Subject: 5800/5900 Jefferson St. NE, Albuquerque, NM

Administrative Amendment Justification Letter
Minor Site plan amendment request
PR-2021-005746_SI-2021-01661
BP-2022-01598

We are requesting an Administrative Amendment for minor changes to our DRB site plan approved November 17, 2021.

Project Number: PR-2021-005746

AS113

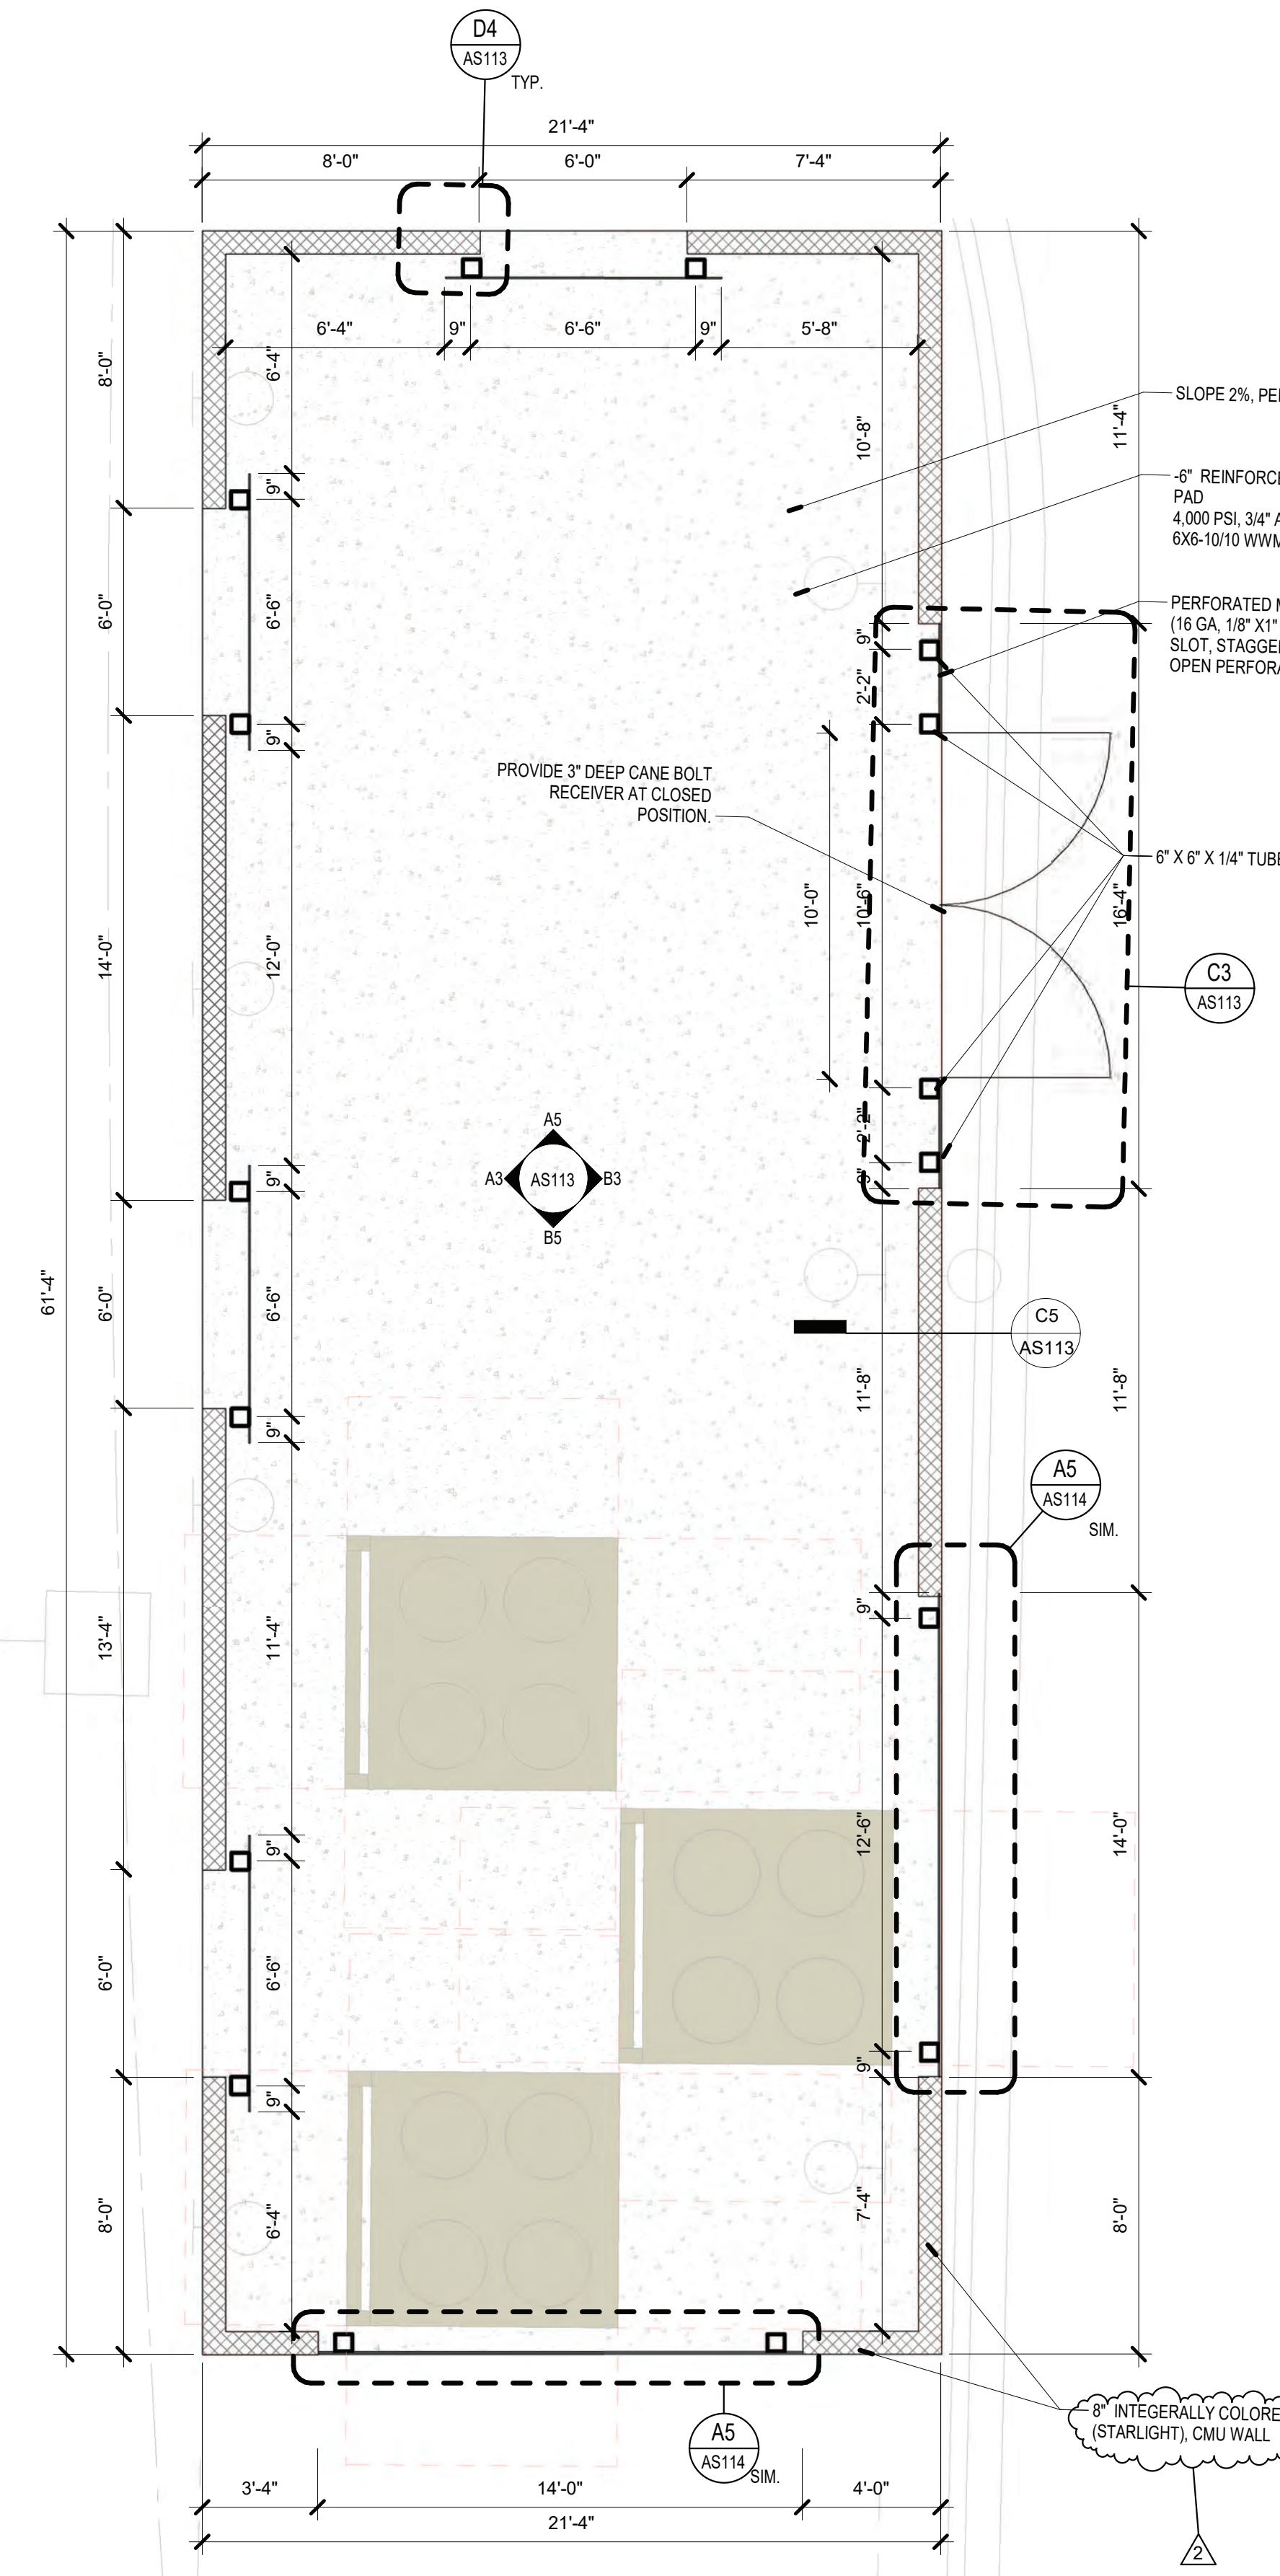
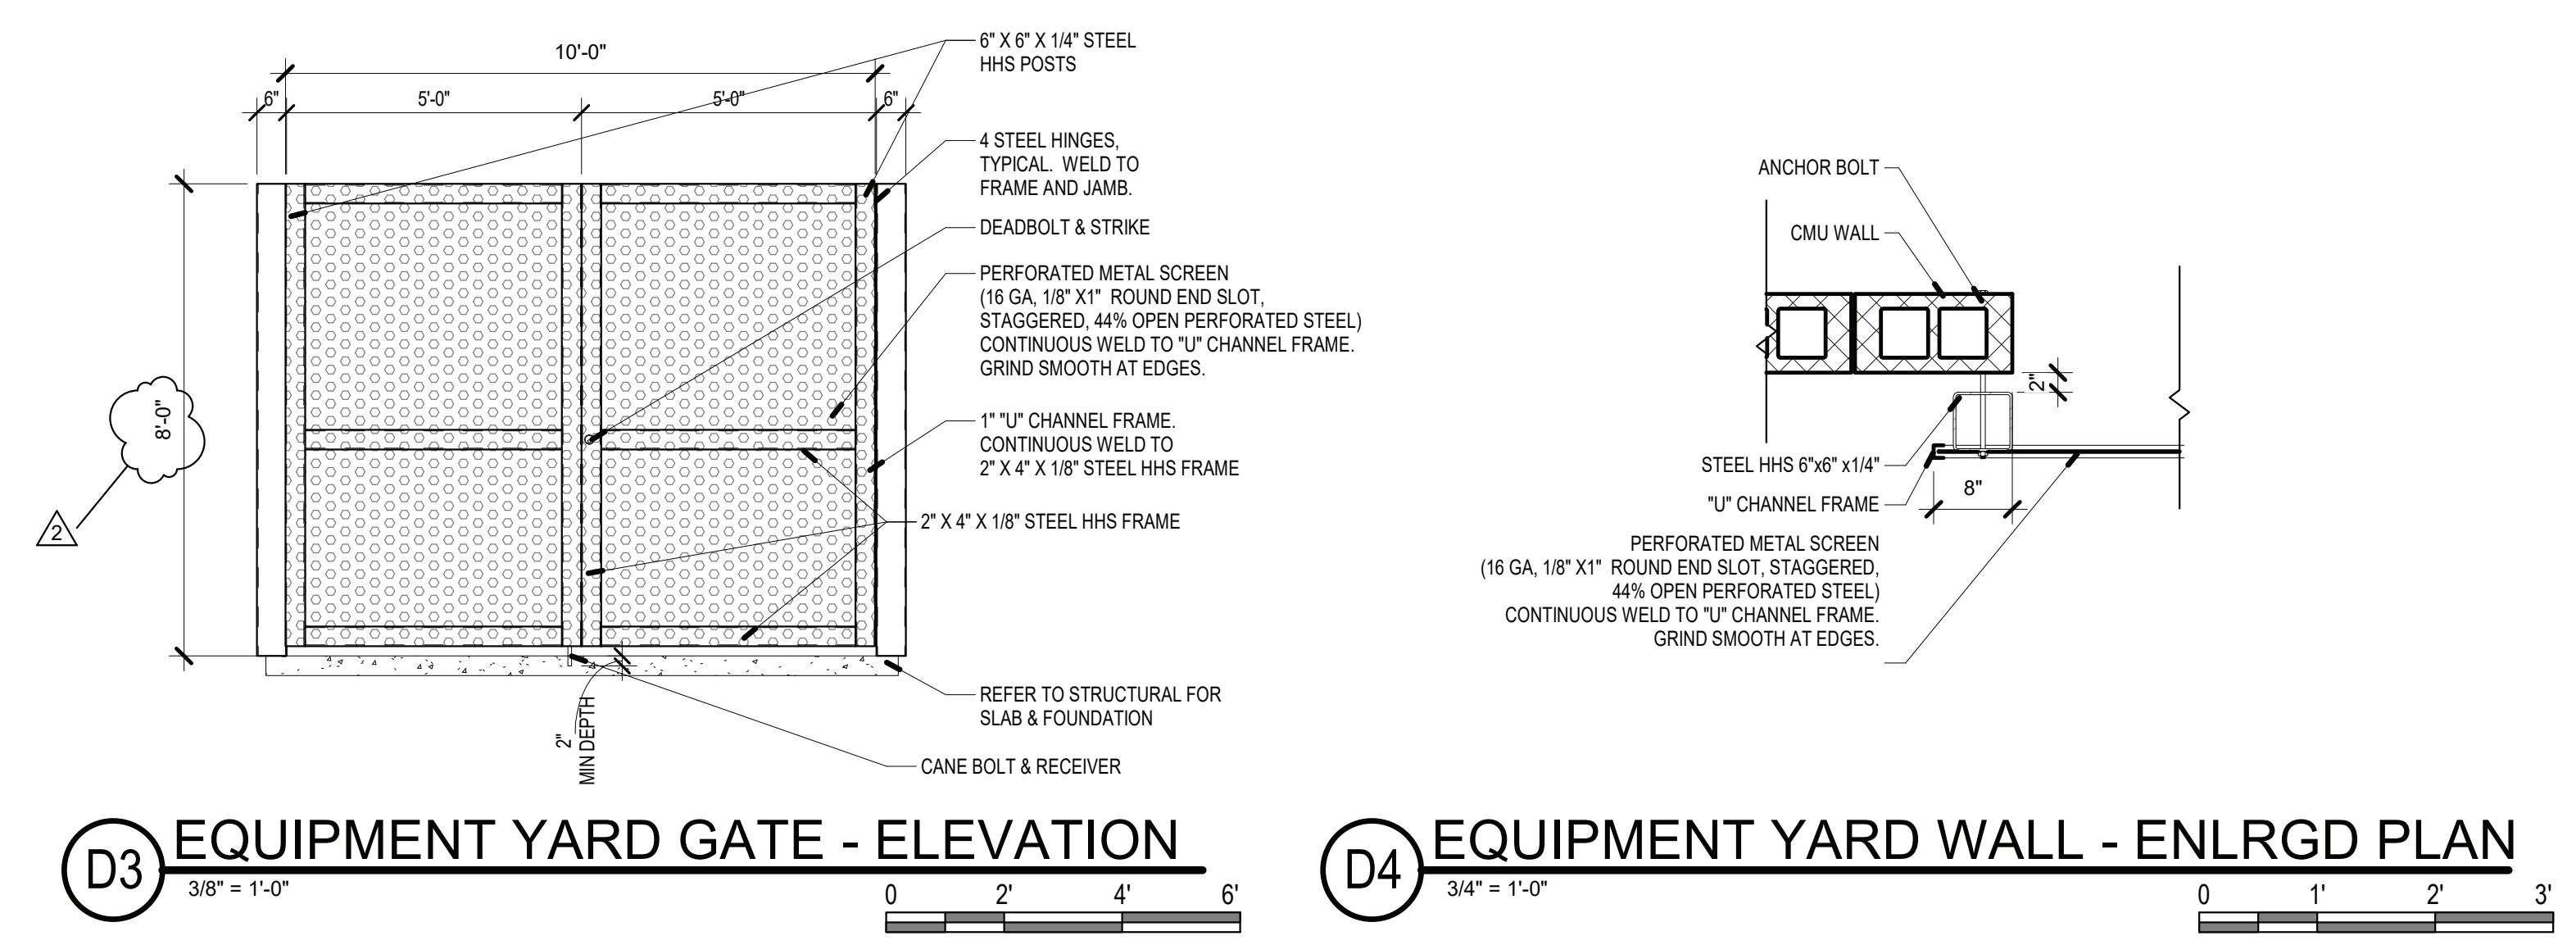
No	Date	Description
2	04/15/2022	ASI 002
Revision Schedule		
ISSUE: SHELL PERMIT		
PROJECT NUMBER: 2120		
FILE: 2120 XRANM_ARCH_Central.rvt		
DRAWN BY: CSC		
CHECKED BY: Checker		
DATE: JAN. 14, 2022
